## **LAURENDINE LANDING SUBDIVISION**

APPLICATION NUMBER 12 DATE September 6, 2018

APPLICANT Laurendine Landing Subdivision

REQUEST Subdivision

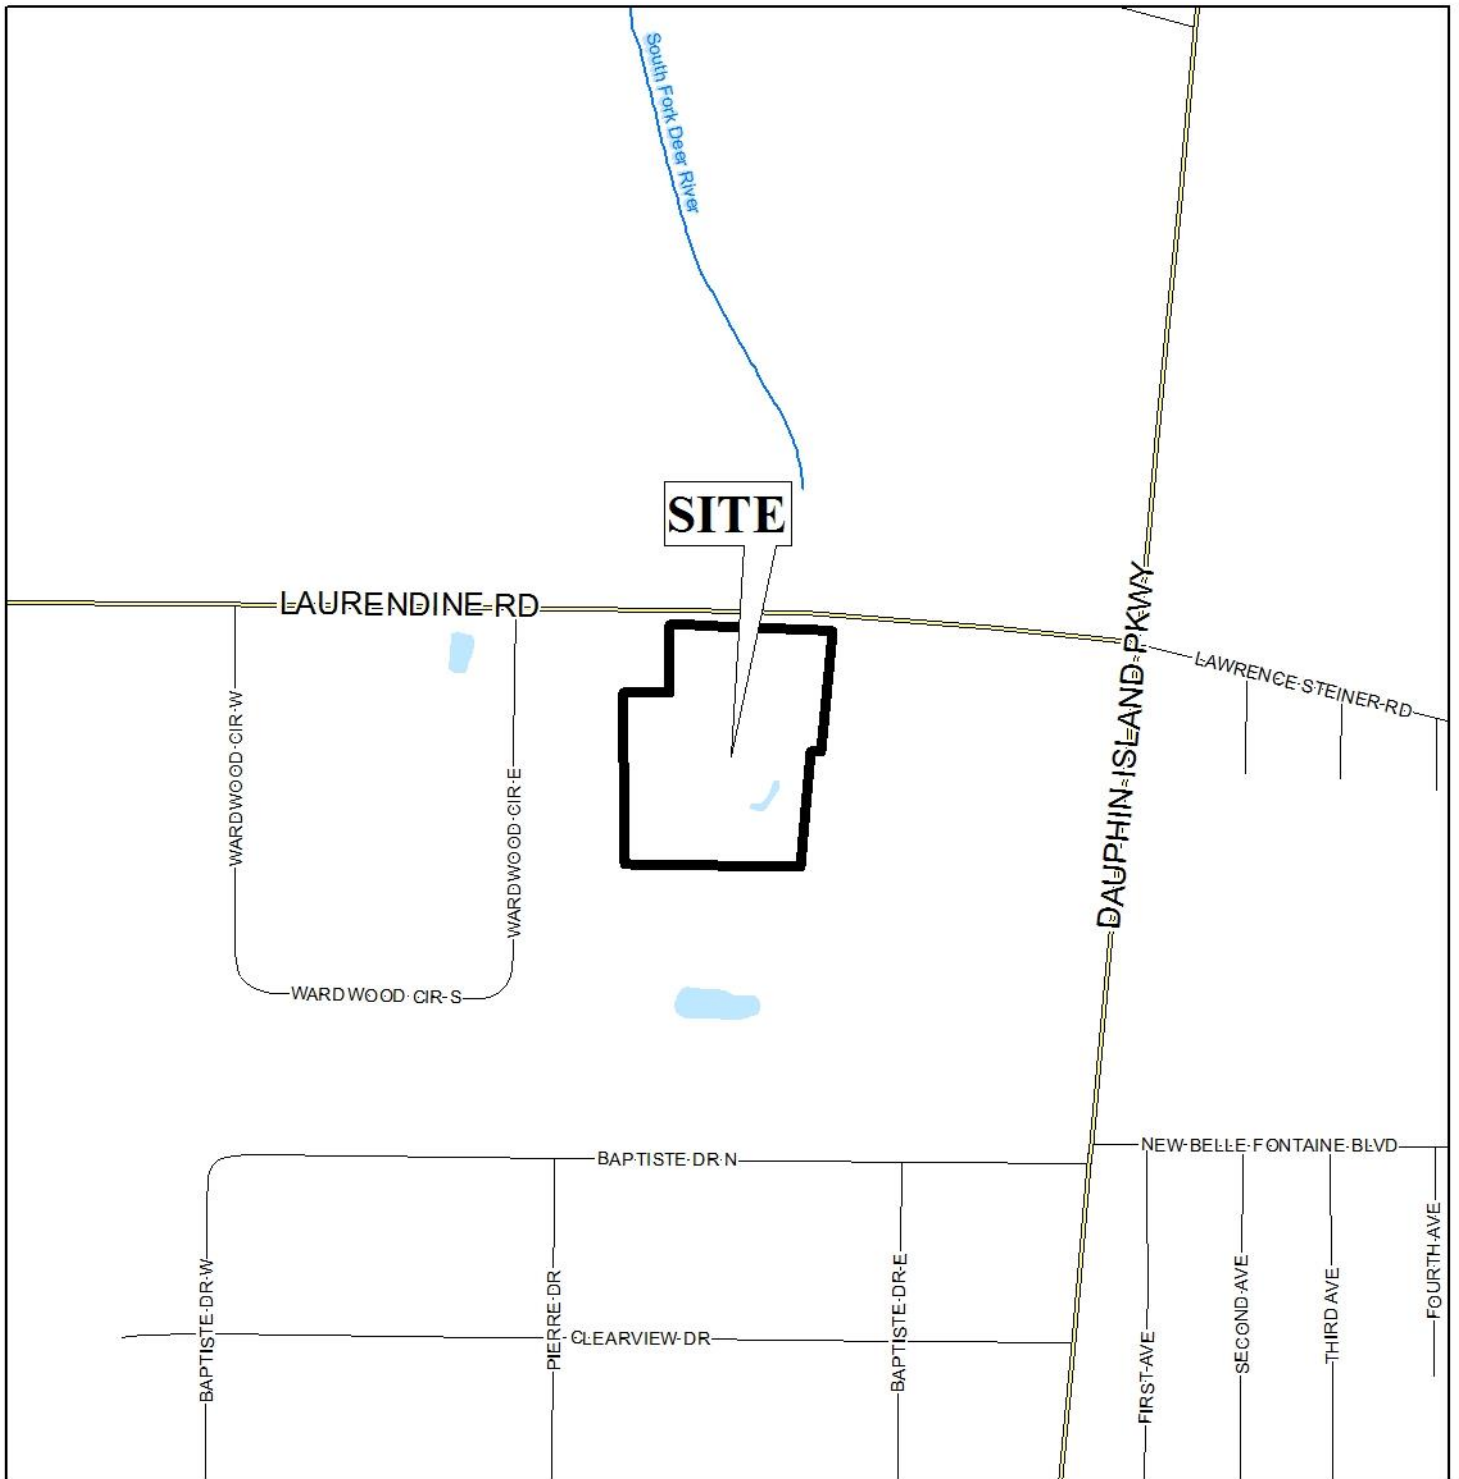
The preliminary plat does not illustrate minimum building setbacks. If approved, a 25' minimum building setback should be illustrated along Laurendine Road.

It should be noted that the proposed Lot 2 does not meet the width-to-depth ratio. Section V.D.3. of the Subdivision Regulations states that lot depth should not exceed 3.5 times the width of the lot at the building setback. The proposed Lot 2 is approximately 83'± wide and more than 614'± deep, resulting in a lot that is approximately 323.5'± deeper than would normally be allowed. There are similarly configured lots in the vicinity; therefore, a waiver of Section V.D.3. of the Subdivision Regulations may be appropriate.

It should also be noted that the preliminary plat illustrates Lot 2 as a flag shaped lot. Section V.D.1. of the Subdivision Regulations state, *"Panhandle or flag lots shall generally not be allowed, but may be permitted only in those locations where varied and irregularly-shaped lot designs are common and the informality of design is consistent with other lots in the vicinity; or, where unusual circumstances such as an odd shaped lot exists; or, separate disparate uses exist on a single lot; or, where there are natural or pre-existing man-made barriers which may cause an undue hardship on the land owner or in the case of a family division"*. The applicant did not provide documentation that this is a family subdivision, and has not indicated what other factors

may necessitate the division as proposed. However, there are several flag shaped lots in the nearby vicinity.

In accordance with Section V.D.2. of the Subdivision Regulations, the proposed lots each exceed the 15,000 square foot minimum lot size requirement for lots served by public water and individual septic systems. The lot size information for each lot is depicted in both square feet and in acres on the preliminary plat and should be retained on the Final Plat, if approved.

As a means of access management, a note should be placed on the Final Plat, if approved, stating that Lots 1, 2 and 3 are limited to one curb cut each, with the size, design and location of the curb cut to be approved by Mobile County Engineering and conform to AASHTO standards.

Based upon the preceding, with a waiver of Section V.D.1. and Section V.D.3., this application is recommended for Tentative Approval, subject to the following conditions:

- 1) Retention of the 80' right-of-way width to Laurendine Road;
- 2) Illustration of 25' minimum building setback line along Laurendine Road for Lots all lots;

- 3) Retention of the lot size information in both square and in acres on the Final Plat;
- 4) Placement of a note on the Final Plat stating that Lots 1, 2 and 3 are limited to one curb cut each, with the size, design and location of the curb-cut to be approved by Mobile County Engineering and conform to AASHTO standards;

- 5) Placement of a note on the Final Plat stating that any lots which are developed commercially and adjoin residentially developed property must provide a buffer, in compliance with Section V.A.8. of the Subdivision Regulations;
